WP-8x3x Release Note

Hardware Revision:

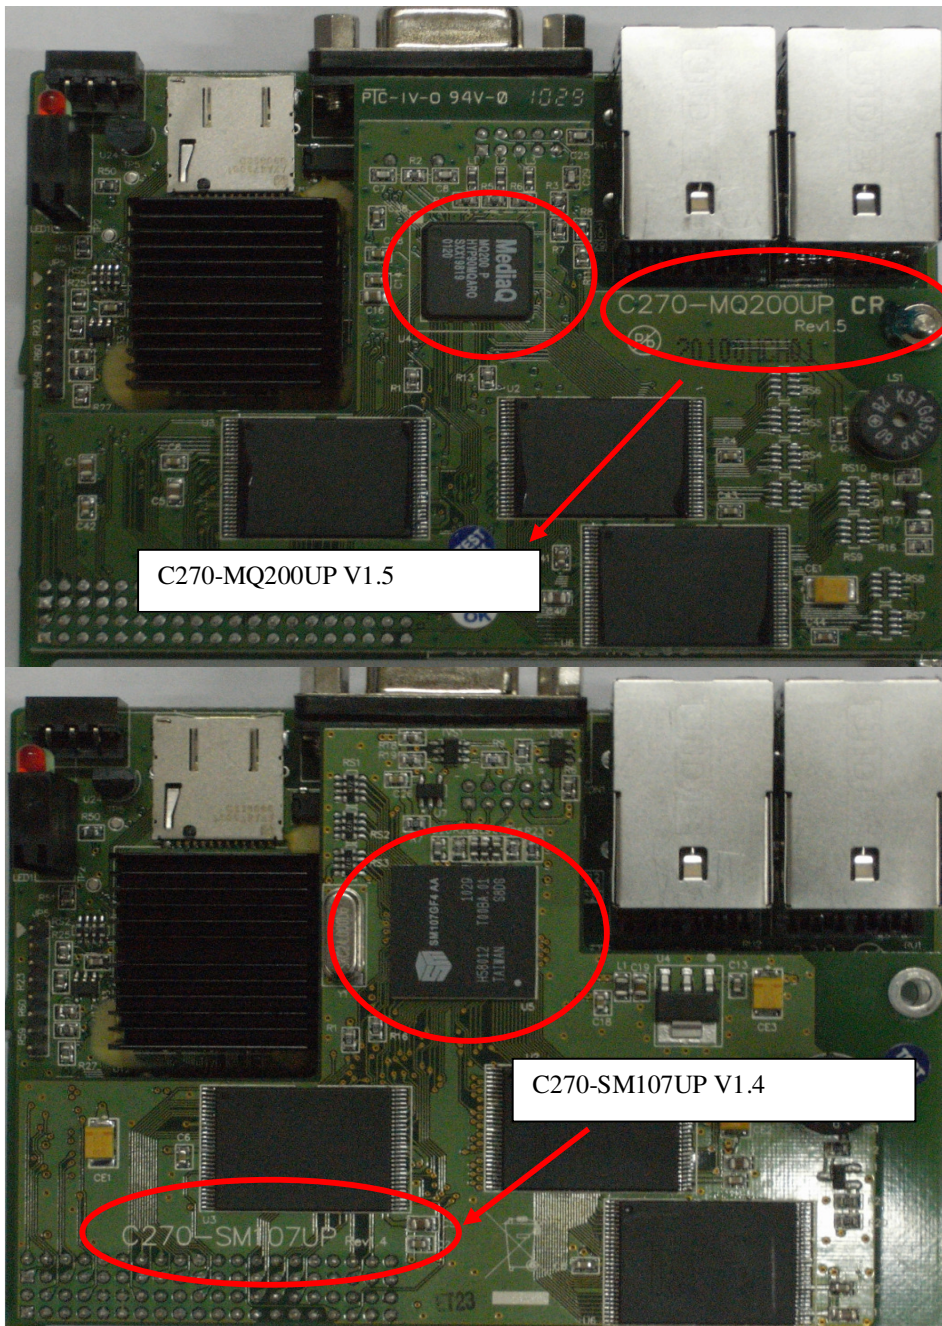
The MQ200 VGA chip was phased out, WP-8x3x replaces it with a SM107GF4 VGA chip since 2011, April, 6th. But the new VGA chip is not 100% compatible to the original one. Thus the OS and Eboot for WP-8x3x must be updated to version 1.2.0.3 and 1.2.1.0 to support both version of the VGA chip.

And please note, the older versions of OS and Eboot don't work on the WP-8x3x that is equipped with the SM107GF4 VGA chips. Don't install the earlier OS and Eboot to it, else it will not boot.

Original MQ200 VGA Chip	New SM107GF4 VGA Chip
Eboot (Ver. 1.2.0.5 and earlier)	Ok	Not working
Eboot (Ver. 1.2.1.0 and later)	Ok	Ok
OS (Ver. 1.2.0.1 and earlier)	Ok	Not working
OS (Ver. 1.2.0.3 and later)	Ok	Ok
